**CEI
IEC
60857**

AMENDEMENT 1
AMENDMENT 1

Pre-recorded optical reflective videodisk system

“Laser vision” 60 Hz/525 lines – M/NTSC

Figure 20 - Characteristic of the RD signal

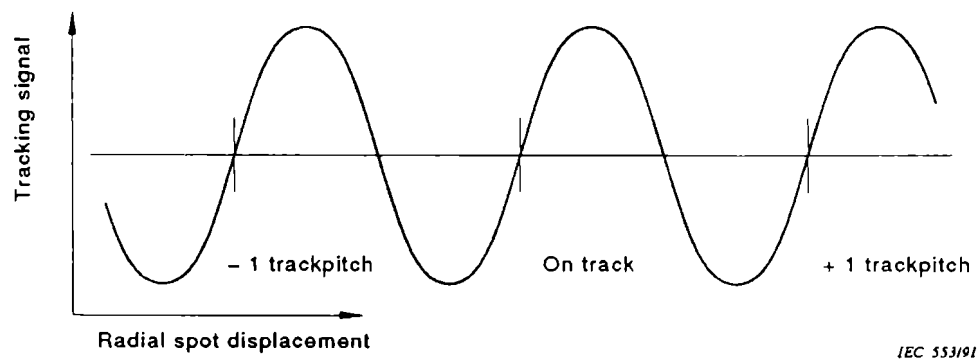
See figure 20. The positive zero-crossing corresponds to the correct radial position of the scanning spot. Figure 21 describes the shape of the shallow pits.

Add, after figure 19, the following new figures 20 and 21:

Typical shape of the error signal for tracking versus radial spot position.
